Technical Note - Response to HCC Comments

- 1.1 This Technical Note has been prepared to provide a response to comments from Hampshire County Council (HCC) in relation the main and emergency site access and to the Internal Layout as shown on the Illustrative Plan (Appendix , which have been prepared to support the outline planning application for the proposed development of the Blue Star Land, Berewood, Waterlooville.

Grainger PLC
Blue Star Land, Berewood, Waterloooville
Technical Note – Response to HCC Comments Part B

drawing number	GTWVILLE_BSL/SK/03	rev.	B
----------------	--------------------	------	---

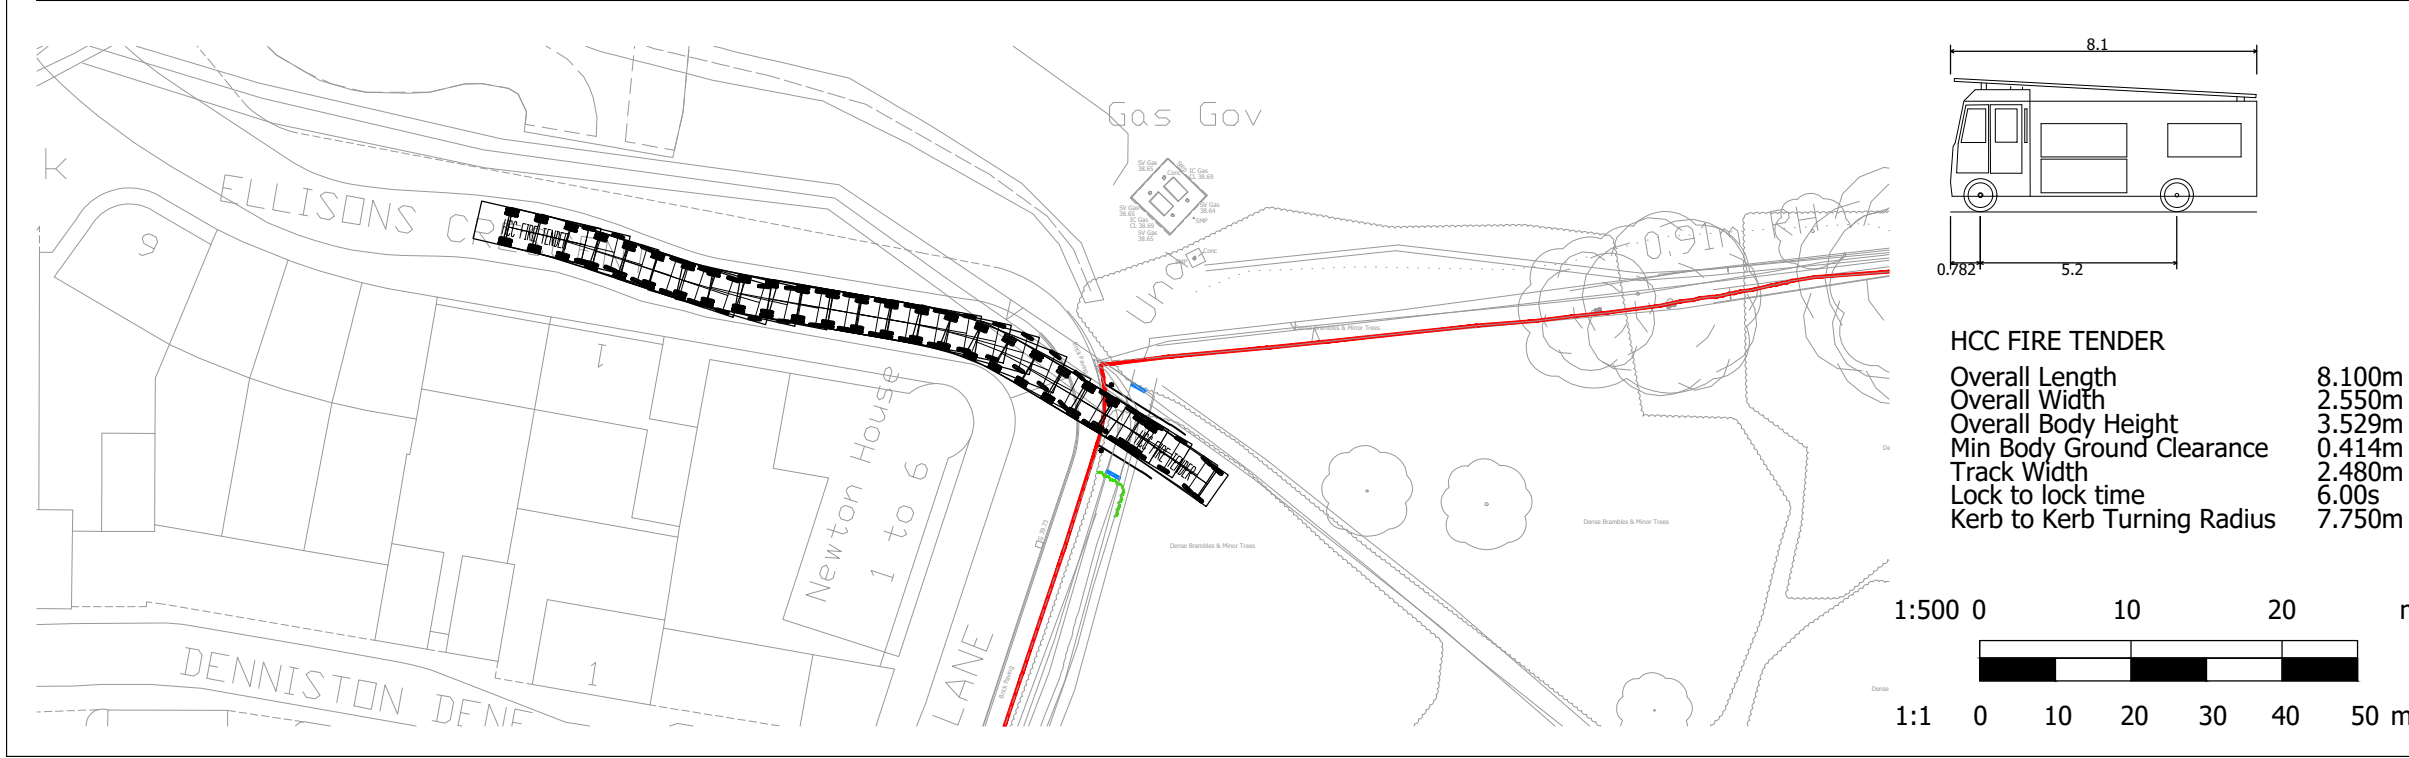
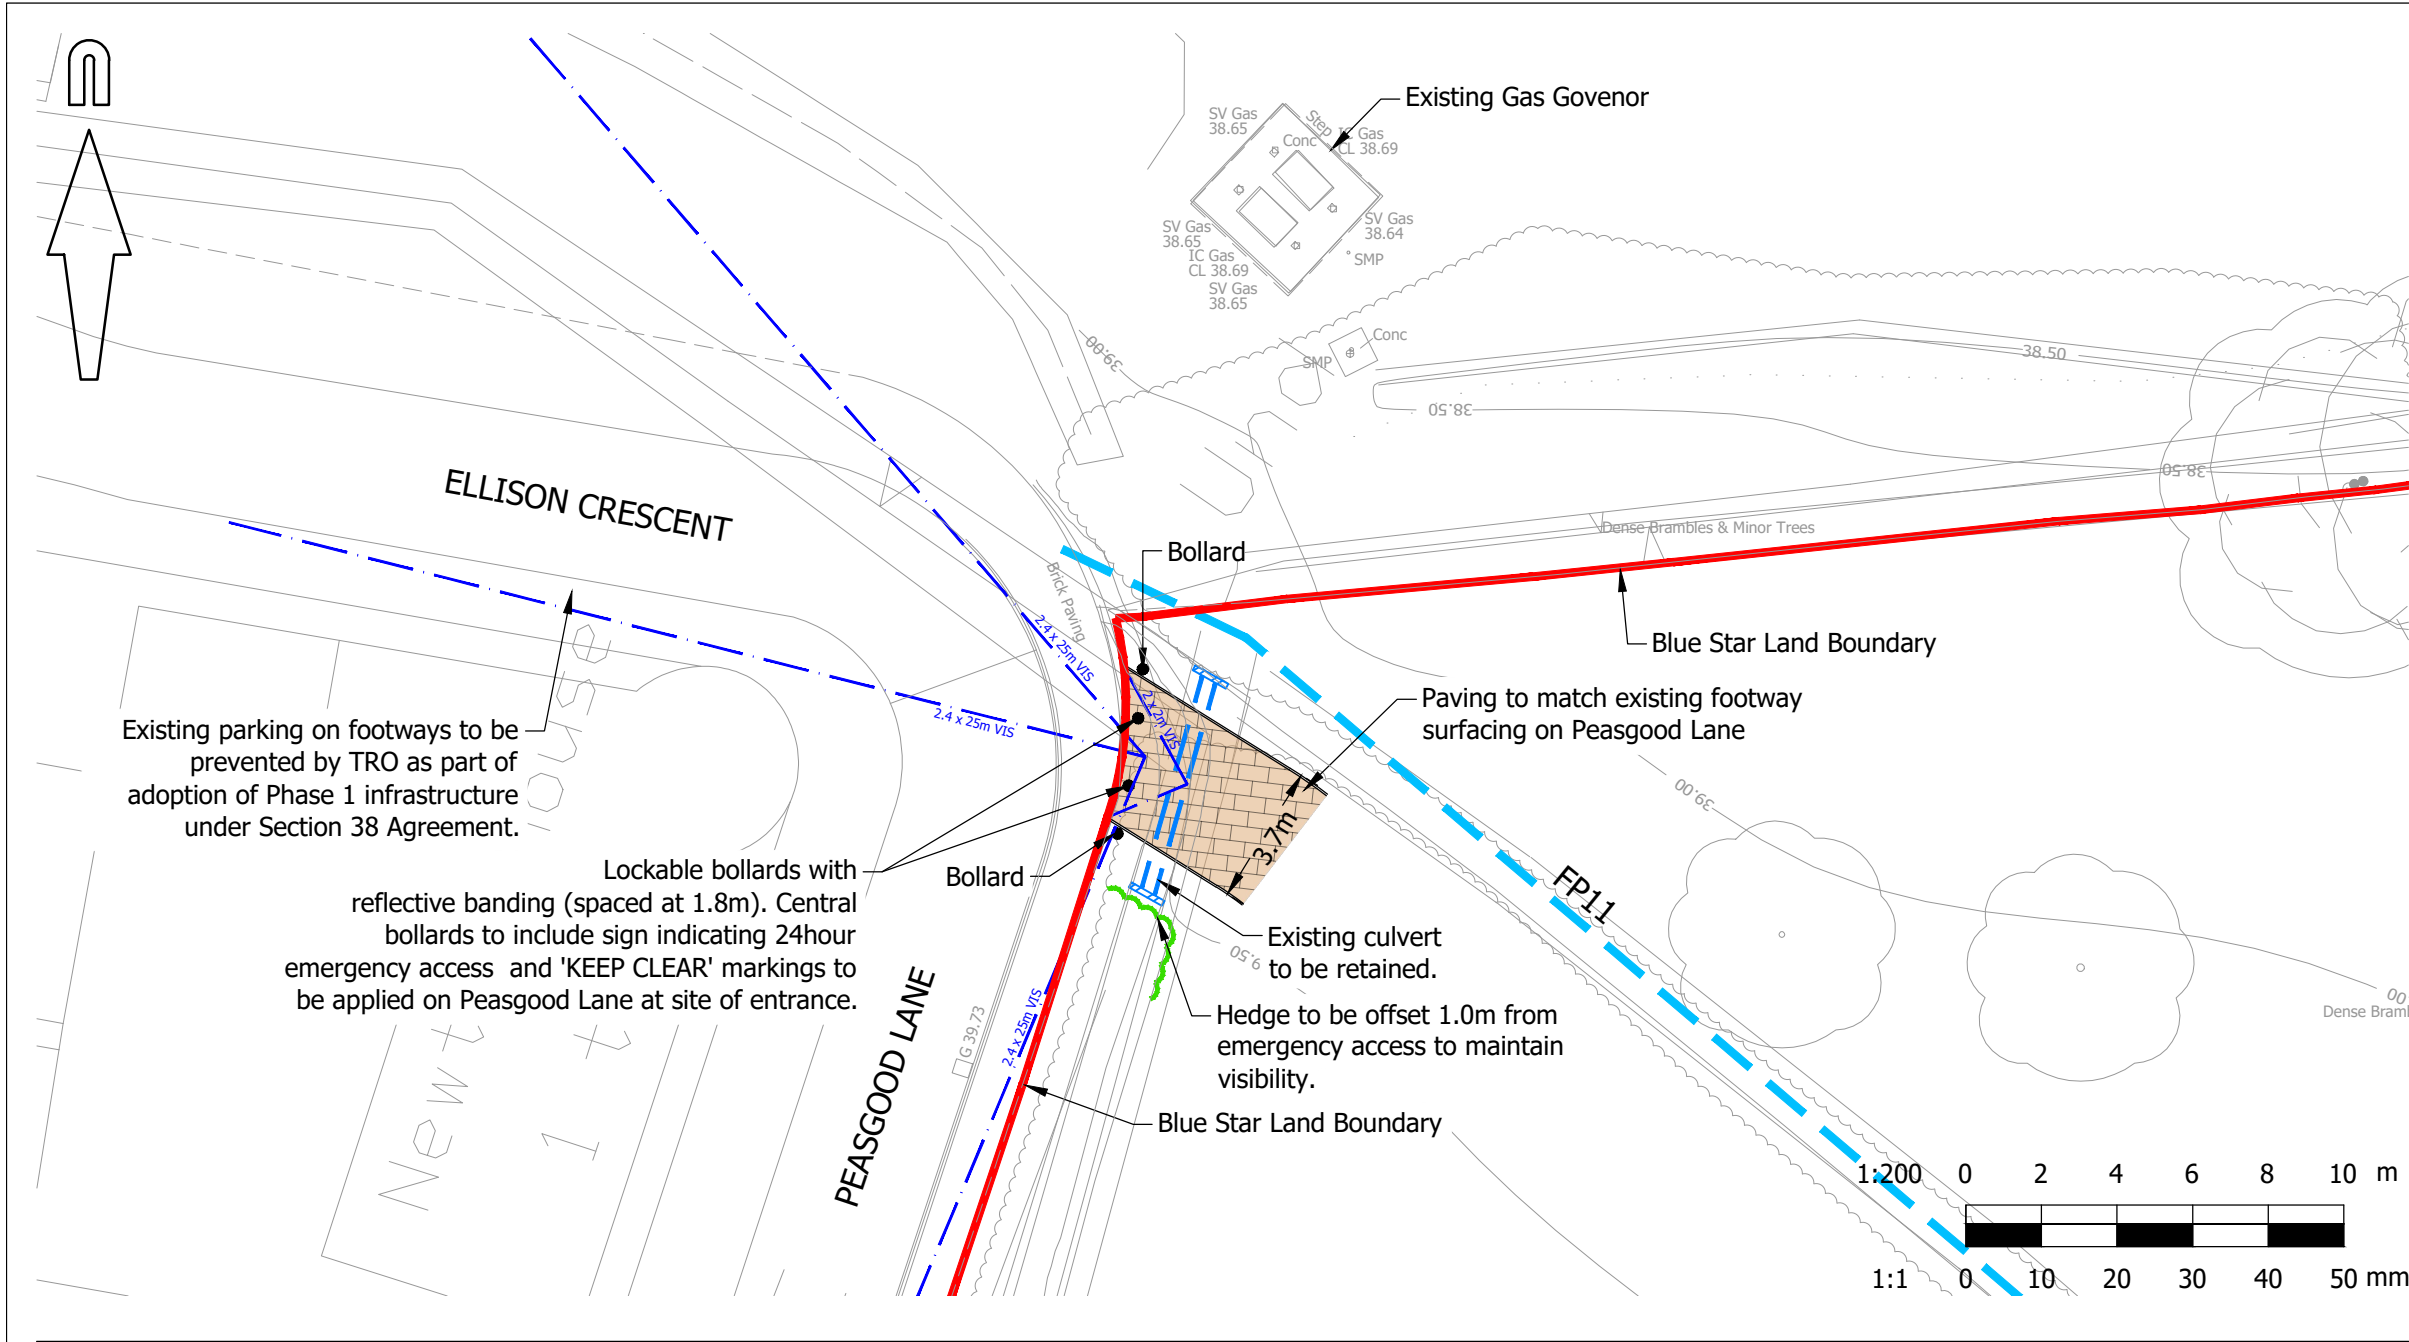
Modal filter should be provided south of Denniston Dene – until the phase 1 residential has been adopted by the Highway Authority engagement with Bloor Homes will be required to introduce the modal filter. Tracking should be provided to ensure that a refuse and fire tender can turn if necessary and distances should be confirmed to ensure that they comply with Manual for Streets.

There are concerns with visibility for both the emergency access and where the cycle path is to join should this fall under 3rd party land ownership.

- Should this emergency access still be pursued, visibility splays and pedestrian intervisibility splays in accordance with HCC TG3 should be provided. Noted
- Tracking speeds should be confirmed for the fire tender and should be undertaken at a minimum speed of 10mph.
- Fire tender dimensions should be 8.68m X 2.18m and not the 7.70m X 2.4m shown on drawing GTWVILLE_BSL_SK/03 Rev A.
- Management of nuisance parking here should also be considered to prevent the blocking of this emergency access point.

- 1.9 There will be the infrequent occasion whereby delivery vehicles and visitors to BSL will wish to enter the BSL site via Peasgood Lane. Dwg. GTWVILLE_BSL/SK/03 indicates that this will be possible without encroaching onto pedestrian areas (apart from where the northern footway crosses the existing vehicular access).

- 1.27 The emergency access is considered necessary in case the main access is obstructed for any reason. Usage of the emergency route by it's very nature will be infrequent and very apparent to non-motorised users of Peasgood Lane/Ellisons Crescent.
- 1.28 Dwg. GTWVILLE_BSL/SK/03 indicates the visibility splays associated with the emergency access can be provided for.
- 1.29 The swept path analysis for all vehicles is shown on Dwg GTWVILLE_BSL/VT/01 and SK/03, the latter being specific to the emergency scenario. Fire tender swept path analysis has used a lock to lock turning time of 6 seconds as recommended in HCC Technical Guideline TG2.
- 1.30 Fire tender swept path analysis has been revised to reflect the required fire tender parameters referred to in TG2.

1.37 Refer to Dwgs GTWVILLE_BSL/SK/02 and 03.

drawing number	GTWVILLE_BSL/VT/01	rev.
----------------	--------------------	------

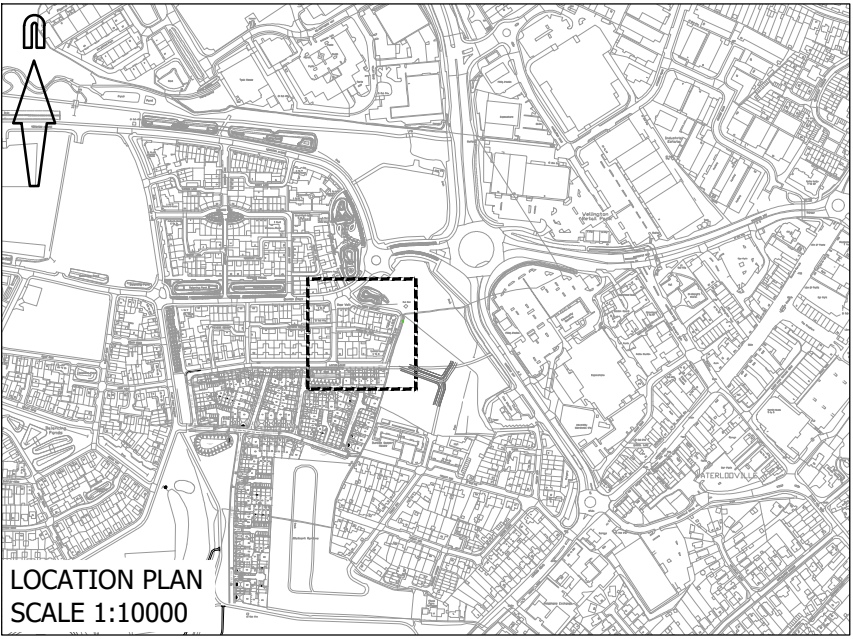
- Tracking needs to be provided for a refuse, fire tender, .com vehicle passing a car along the extent of Laxton Leaze entering the site as well as two cars passing – this should be undertaken at 10mph.
- Should Peasgood Lane not be closed then tracking should be provided for all movements accessing and egressing the site from Peasgood Lane

- 1.31 Refer to Dwg. GTWVILLE_BSL/VT/01.
- 1.32 Swept path analysis follows guidance set out in TG2 Section 3.2.8. It is noted that the referred refuse vehicle cannot negotiate Ellisons Crescent and Peasgood Lane without utilising the full width of the shared use corridor (encroaching into the margins either side of the defined running lane. It is not known whether the inappropriate parking disrupts refuse collection or whether a smaller vehicle is used in this area.
- 1.33 Assuming the maximum compliant size vehicle is used then refuse vehicles visiting the BSL development could arrive and leave via Laxton Leaze.
